RE: 14 Distribution Drive, Orchard Hills – Request for Additional Information - Transport Statement (SSD18204994)

TABLE 1 RESPONSE TO SEARS – SSD 18204994

Attachment B
Proposed Site Plan

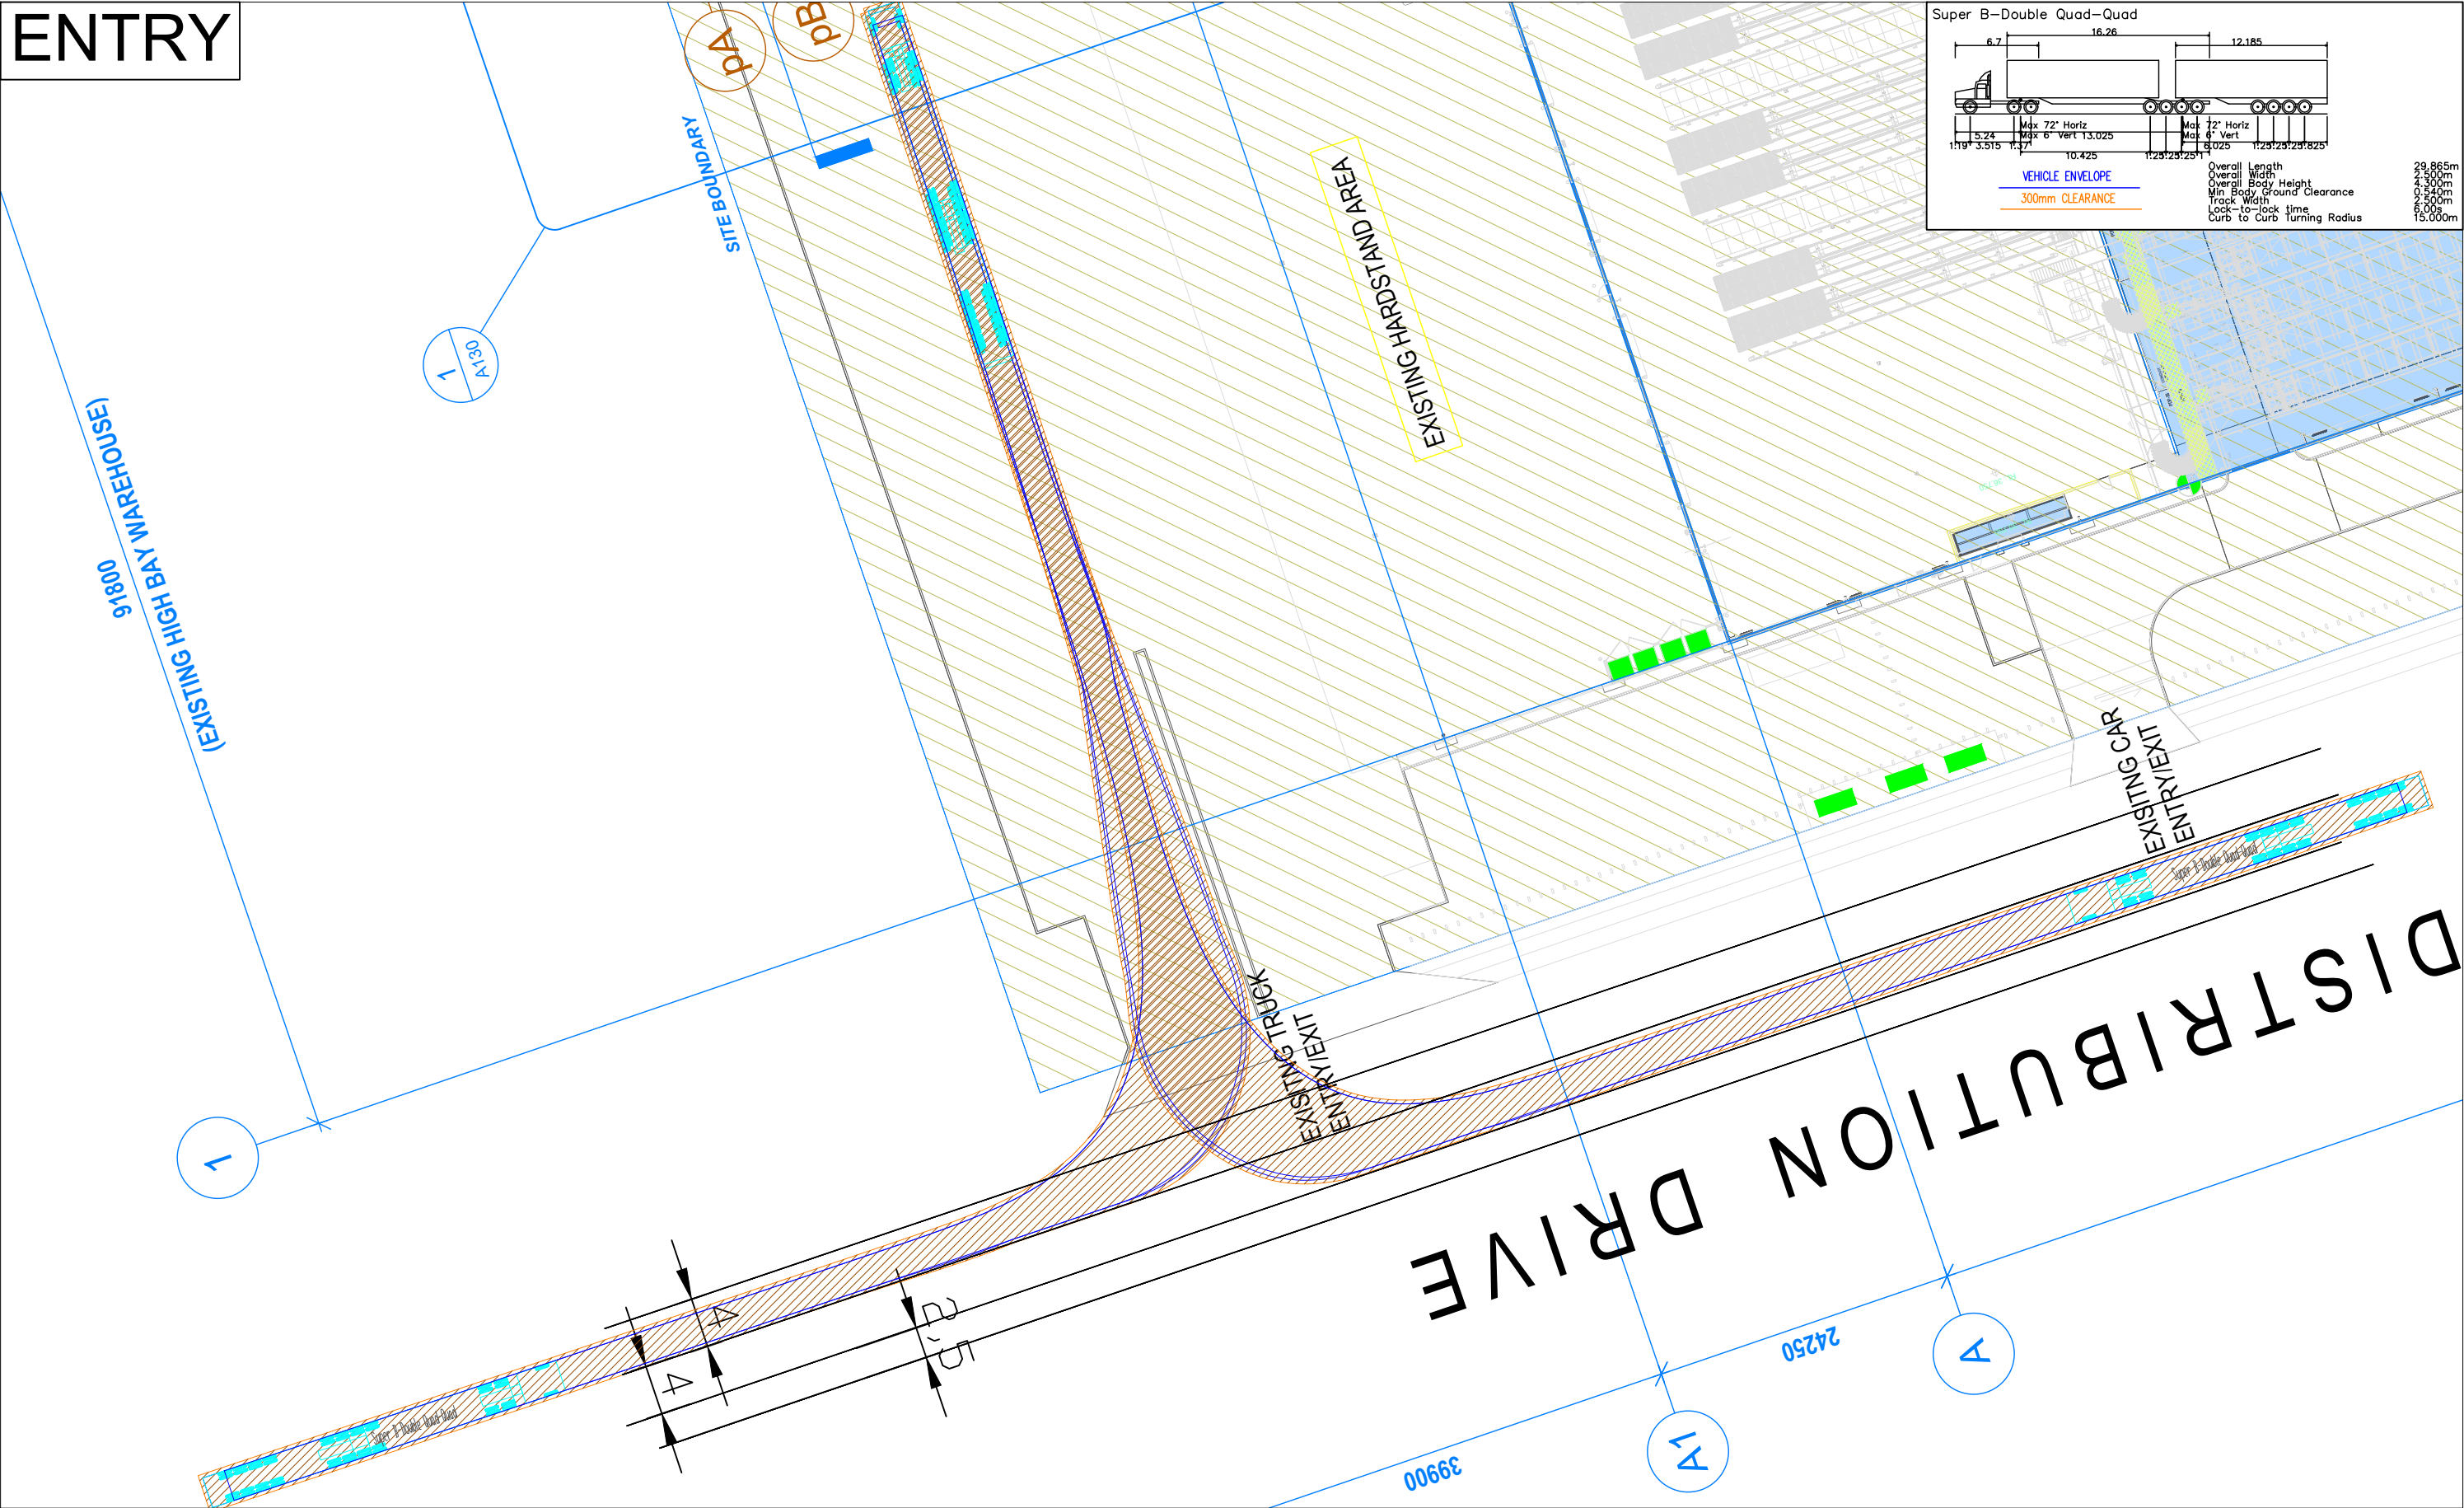
3	The TA states that a total of 274 car parking spaces are proposed for the overall Lot 10 & 11 site, including an additional 160 spaces (as part of the extension) to the existing 114 spaces. This is still a deficit of 183 spaces in accordance with the Mamre West DCP. TfNSW raises the question as to how will this impact the	As discussed in the Ason Group Transport Assessment (ref: 1654r01v7), it is expected that there will be up to 380 employees (415 during seasonal peak periods) over 24 hours which are broken up over the day, afternoon, night and office shifts.

circulation in the local network and interface with Mamre Road.	<p>At any given time, the maximum on-site parking demand for the Site is expected to be approximately 226 spaces during non-seasonal peak periods and 259 spaces during seasonal peak periods.</p> <p>Notwithstanding, it is noted that the amended Site plan (shown within Attachment B) provides 8 less car parking spaces when compared to the Site plan referenced with the original TA. Therefore, the total car parking provision is now 266 (when compared to 274 within the previous Site plan).</p> <p>The proposed 266 car parking spaces are considered sufficient to accommodate the actual on-site parking demand (as determined by the First Principles Assessment).</p> <p>In summary, the First Principles Assessment undertaken as part of the original TA confirms that the proposed on-site parking supply will be sufficient to accommodate the Snack brands operation for Stages 1 and 2.</p>

Drawing Number:

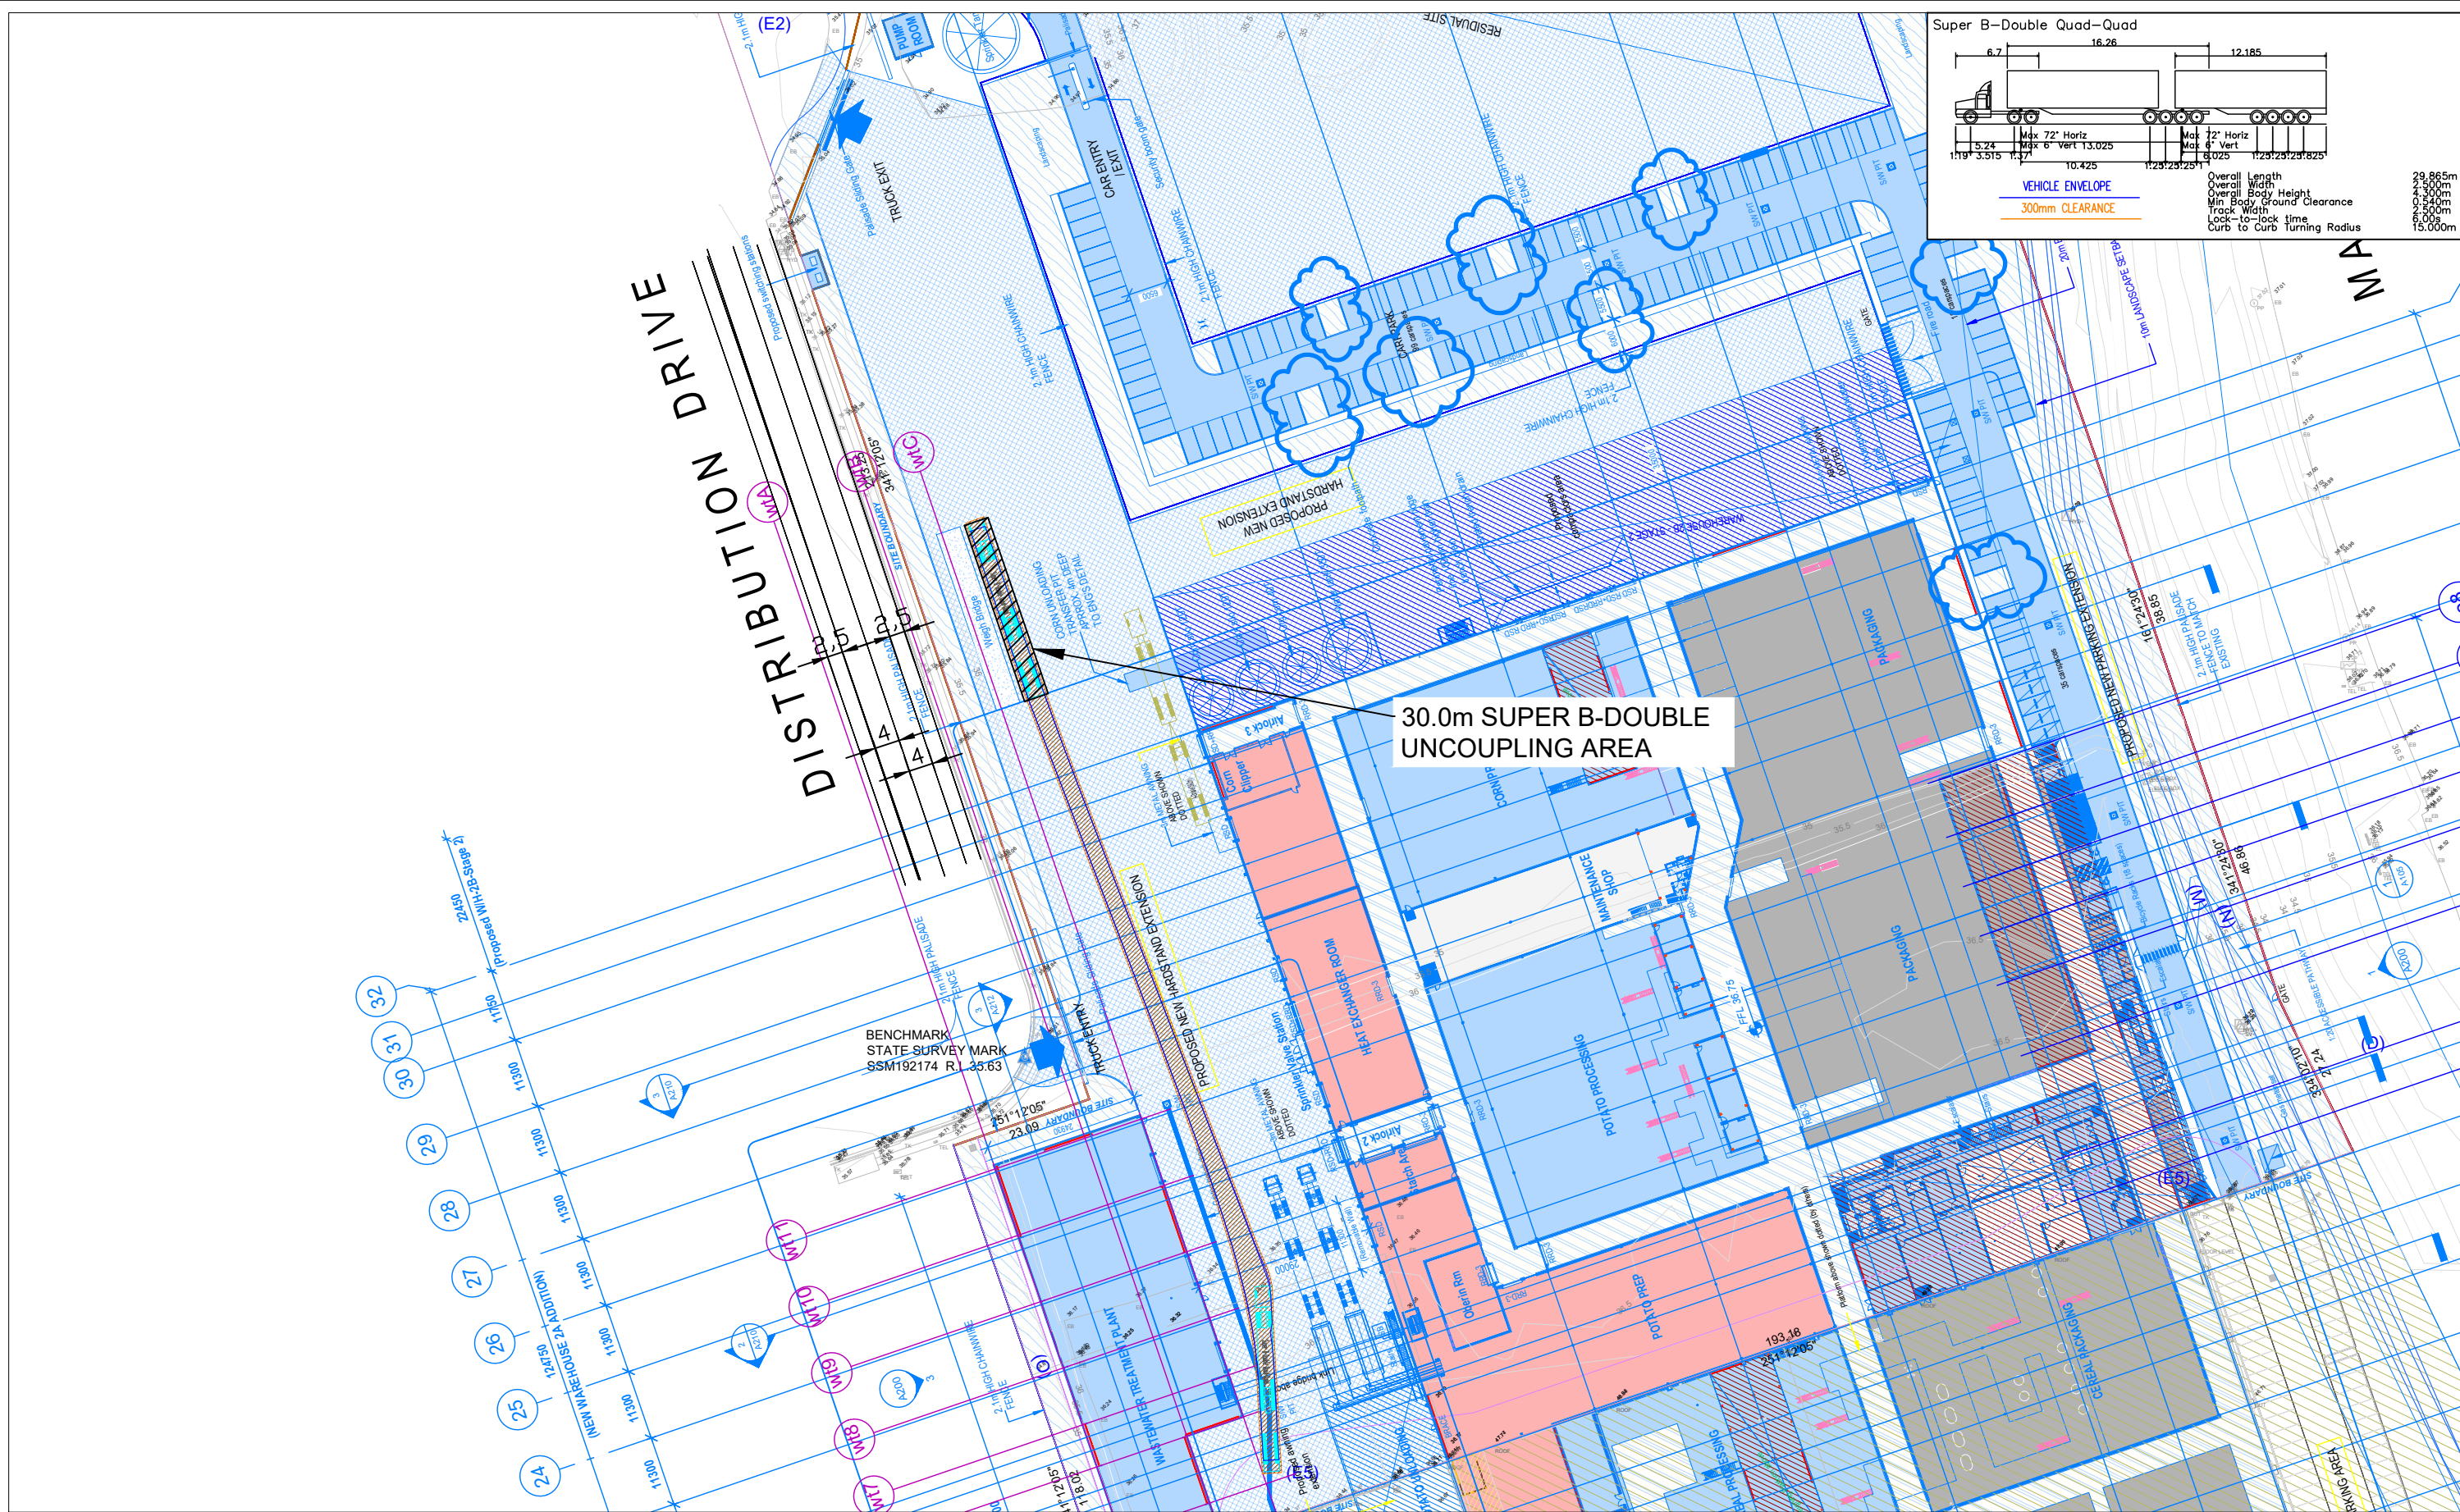
7	<p>Mamre Road is an approved PBS 2B route and large industrial development within Western Sydney Employment Area should consider PBS 2B as the design vehicle. However, the Transport Assessment (TA) site accesses and internal hardstand areas have been designed to cater for trucks of up to 26.0 metres B-doubles.</p> <p>The TA needs to graphically demonstrate site accesses and internal hardstand areas have been designed to cater for trucks of up to a 30m PBS Level 2B vehicle.</p>	<p>Refer to Attachment C which showcases the swept path assessment with the 30.0m PBS Level 2B vehicle (30.0m Super B-double truck) as the chosen design vehicle.</p> <p>The swept path assessment indicates that the 30.0m Super B-double truck can enter and exit the Site as required. Furthermore, the swept path assessment also demonstrates the 30.0m Super B-double truck manoeuvring through the hardstand area.</p>
8	<p>The TA has acknowledged two RSDs where B-doubles will be need to be reversed to unload from the rear. As the rear trailer is in the way, the front trailer (or A-trailer) of a B-double is typically unloaded by de-coupling the trailers, or jack-knifing the combination.</p> <p>The TA needs to clarify whether a de-coupling area is required so that both the 'A' and 'B' trailers can be unloaded from the rear for the two RSDs which require Bdouble reverse movements</p>	<p>Refer to Attachment C which shows the proposed de-coupling area on AG03 and AG04. The decoupling zone is in line with the relevant AS requirements.</p> <p>Furthermore, a swept path analysis has been undertaken to indicatively show the operation of this zone as well.</p>
